RENESAS TECHNICAL UPDATE

Product Category	MPU/MCU		Document No.	TN-RX*-A0241B/E	Rev.	2.00
Title	RX110 Group, RX111 Group Errata to User's Manual: Hardware Regarding the Realtime Clock (RTC)		Information Category	Technical Notification		
Applicable Product	RX110 Group, RX111 Group	Lot No.	Reference Document	RX110 Group User's Manual: Hardware Rev.1.20 (R01UH0421EJ0120) RX111 Group User's Manual: Hardware Rev.1.30 (R01UH0365EJ0130)		
		All

This document describes corrections to the "Realtime Clock (RTC)" chapter in User's Manual: Hardware for the applicable products.

Figure 21.3 Clock and Count Mode Setting Procedure

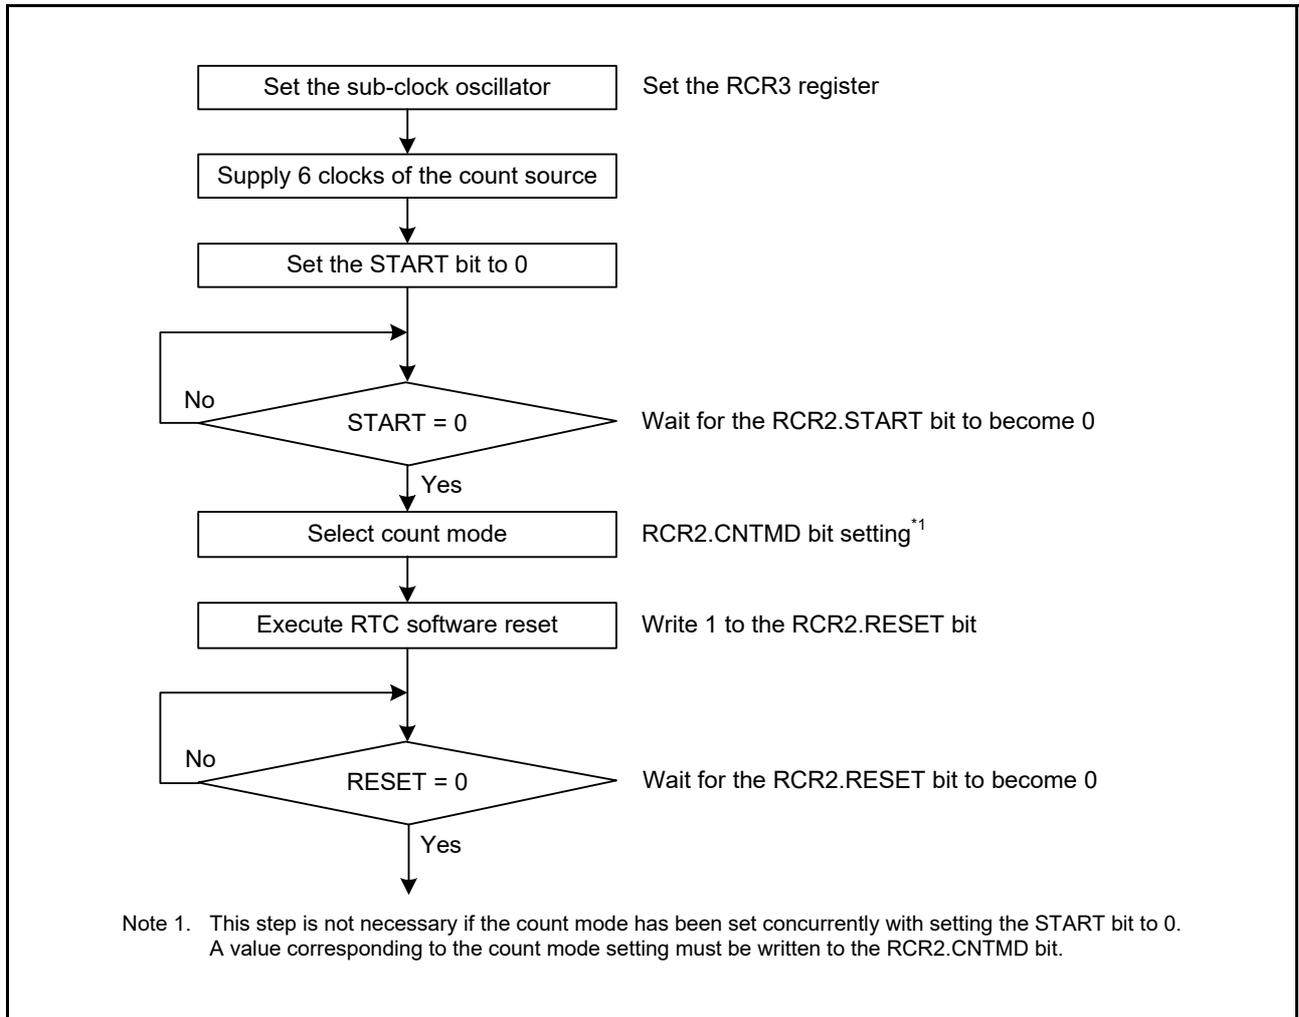
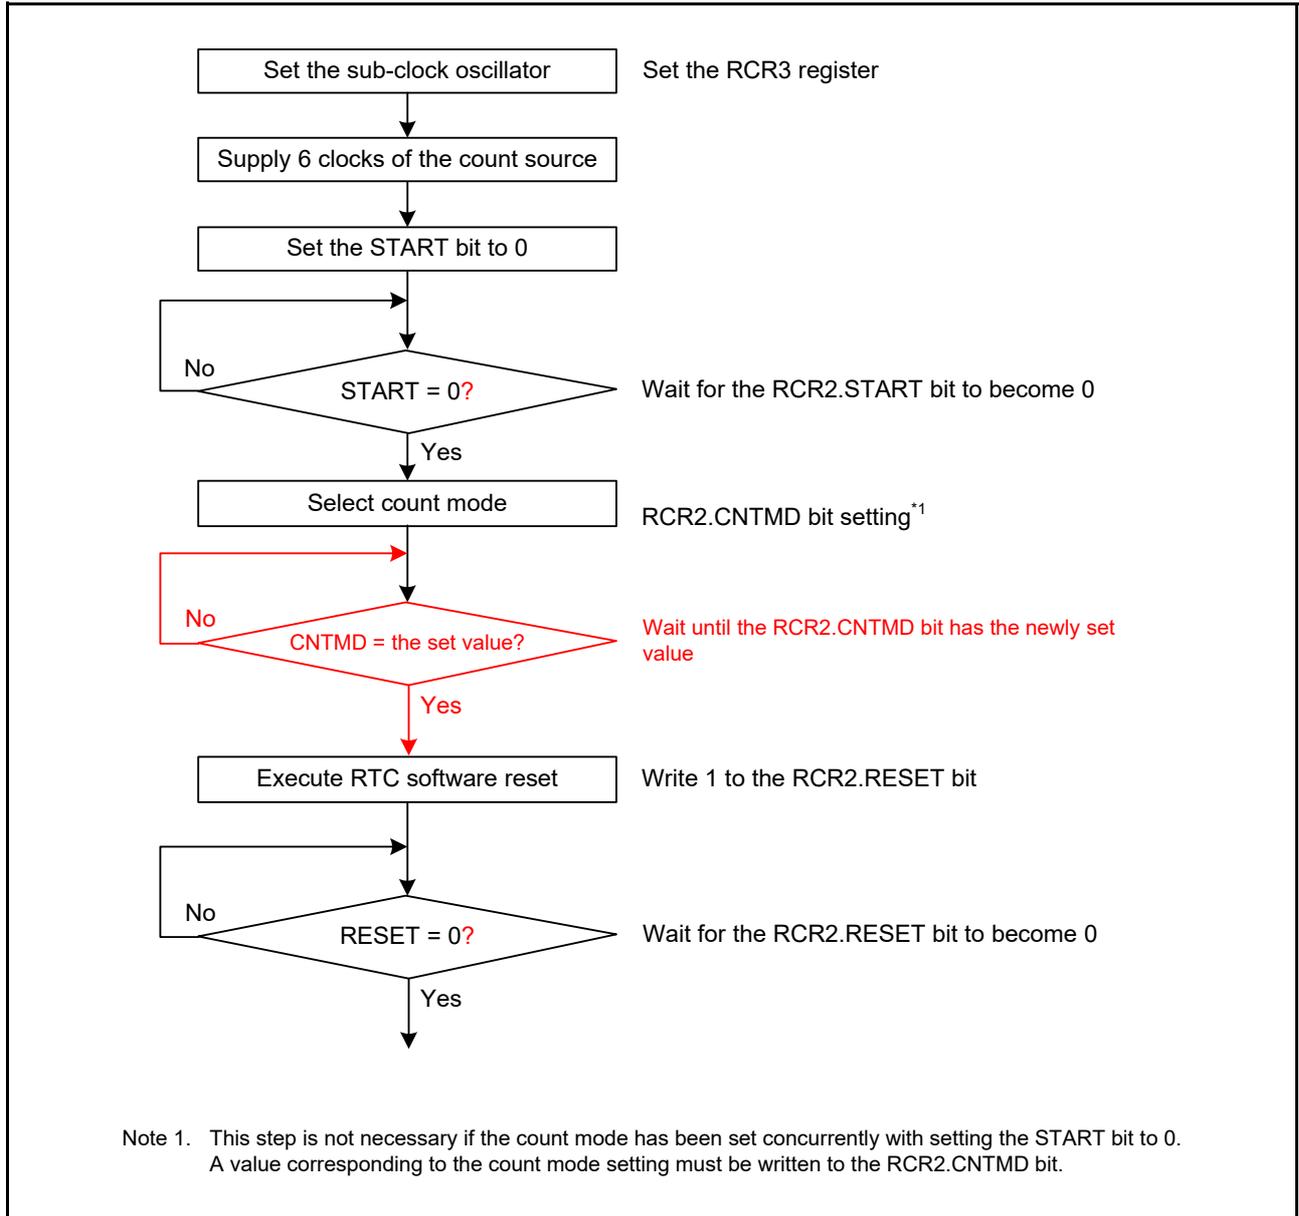
The setting procedure described in Figure 21.3, Clock and Count Mode Setting Procedure is corrected as follows.

Figure 21.12 Initialization Procedure

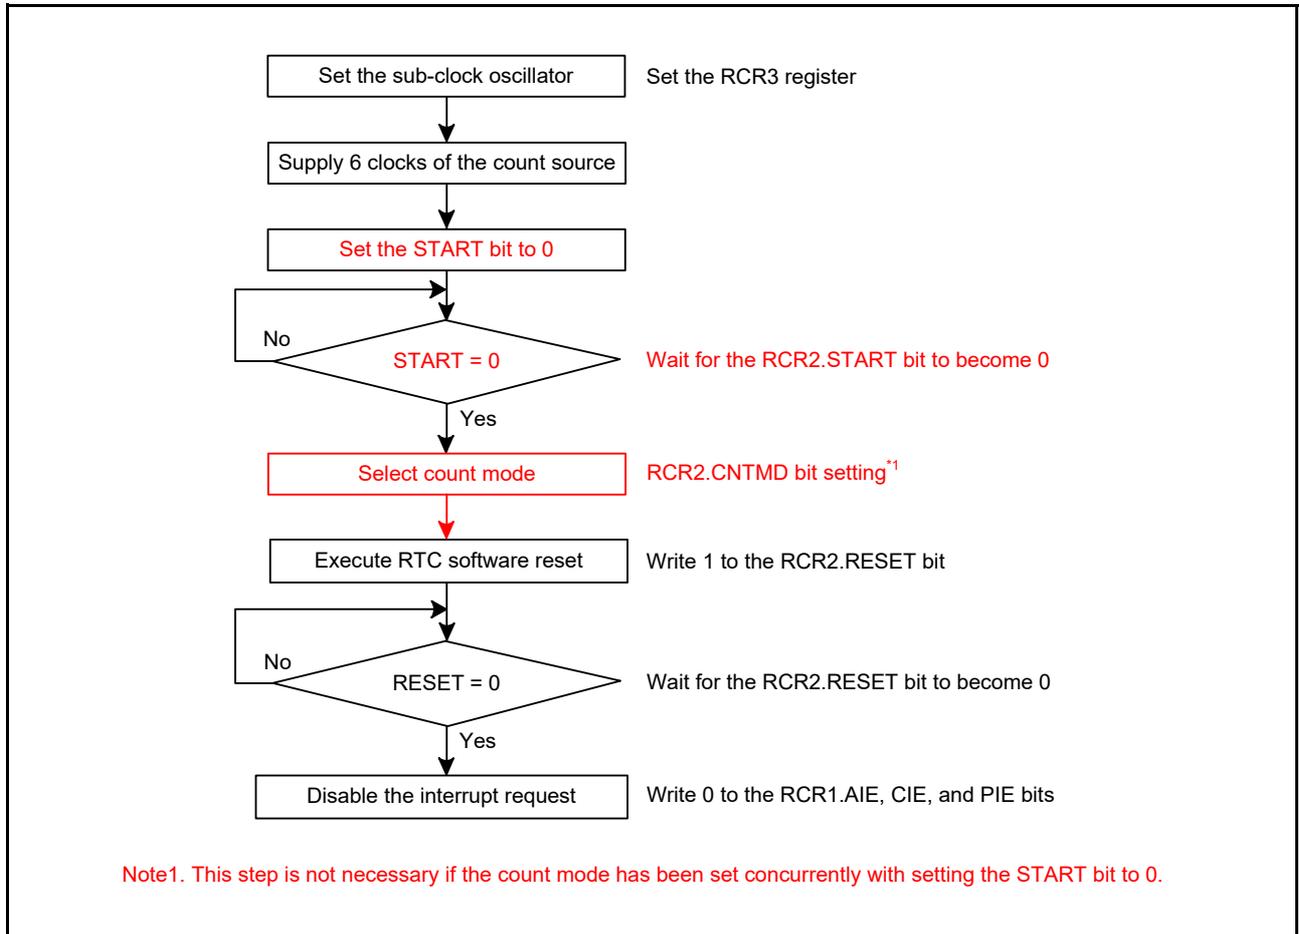
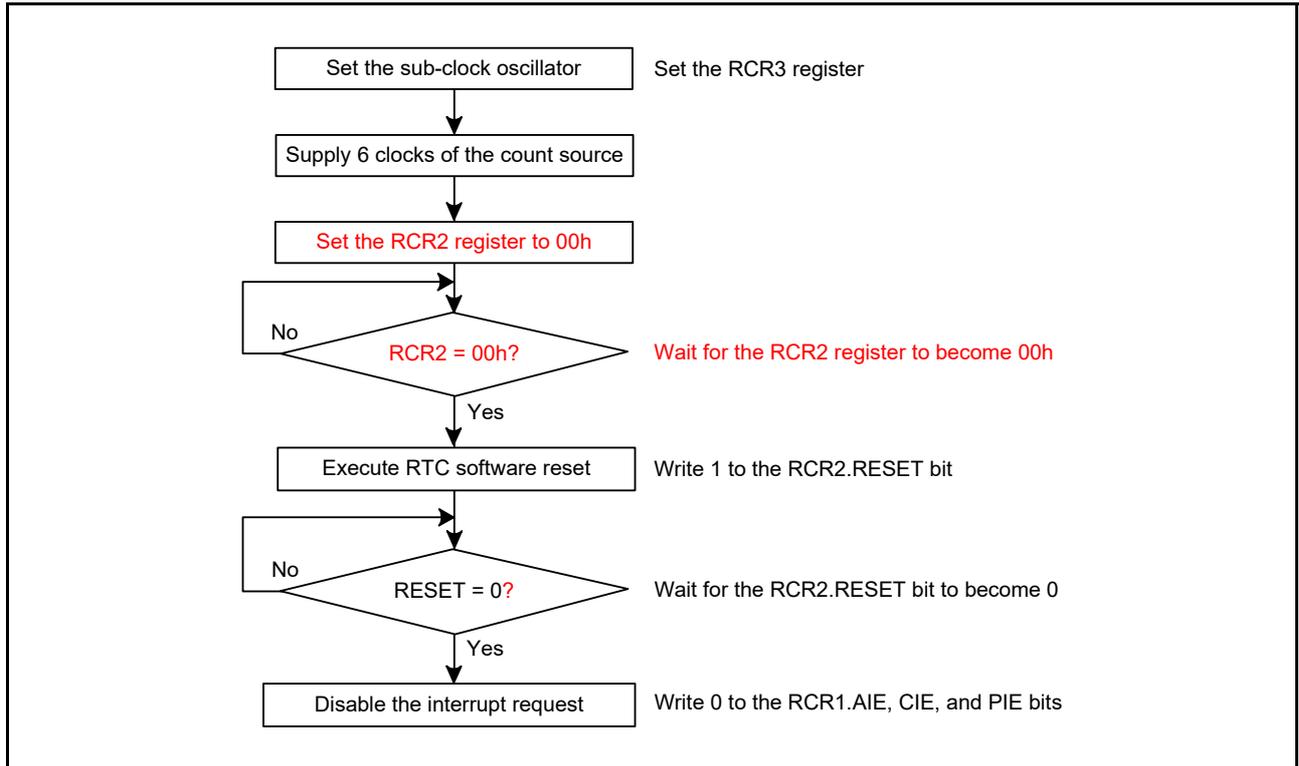
The initialization procedure described in Figure 21.12 of section 21.5.7 Initialization Procedure When the Realtime Clock is Not to be Used is corrected as follows.
